Access Compliance Report

Public Rights-of-Way

(Curb Ramps)

Intersection ID: 3658	Main Street: DAVIS_LAKE_PY	Cross Street: HARRIS_GLEN_DR	Location: W
ADA ID: CE0F5991B49D	Ramp Type: Perp	Initial Pass/Fail: Fail	Overall Compliance: No
Severity Score: 10			
Codes/Mitigation Info/Possible Solution		Field Measurements/Component Compliance

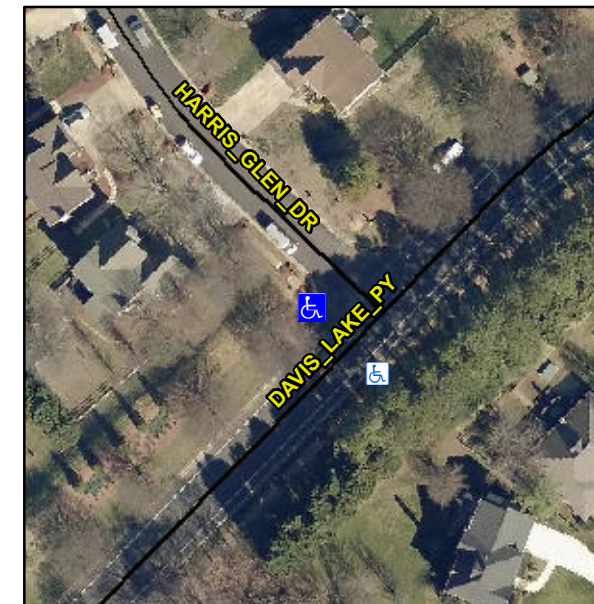
Not Found, R304.5.1, R304.5.3

Compliance	Description	Data	Compliance	Description	Data
N/A	Ramp Length (in)	51.0	Yes	Ramp Slope (%)	6.0
No	Ramp Width (in)	38.0	No	Ramp XSlope (%)	3.7
N/A	Flare Type LT	N/A	N/A	Flare Type RT	N/A
N/A	Flare Slope LT (%)	N/A	N/A	Flare Slope RT (%)	N/A
N/A	Flare Traversable LT?	N/A	N/A	Flare Traversable RT?	N/A
N/A	Landing Length (in)	N/A	N/A	DWS Provided?	N/A
N/A	Landing Width (in)	N/A	N/A	DWS Contrast?	N/A
N/A	Landing Slope (%)	N/A	N/A	DWS Length (in)	N/A
N/A	Landing X Slope (%)	N/A	N/A	DWS Full Width?	N/A
N/A	Landing Curb? (Y/N)	N/A	N/A	DWS Offset (in)	N/A
N/A	Shared Landing?	N/A			
N/A	Gutter Ponding?	N/A	N/A	Gutter Slope (%)	N/A
N/A	Gutter Lip Ht (in)	N/A	N/A	Gutter X Slope (%)	N/A
N/A	Painted X Walk1?	No	N/A	Painted X Walk2?	N/A
	X Walk 1 Direction	To SE		X Walk 2 Direction	N/A
N/A	X Walk 1 Width (in)	N/A	N/A	X Walk 2 Width (in)	N/A
	X Walk 1 Slope (%)	0.9		X Walk 2 Slope (%)	N/A
	X Walk 1 X Slope (%)	2.2		X Walk 2 X Slope (%)	N/A

Remove & Replace Entire Ramp.
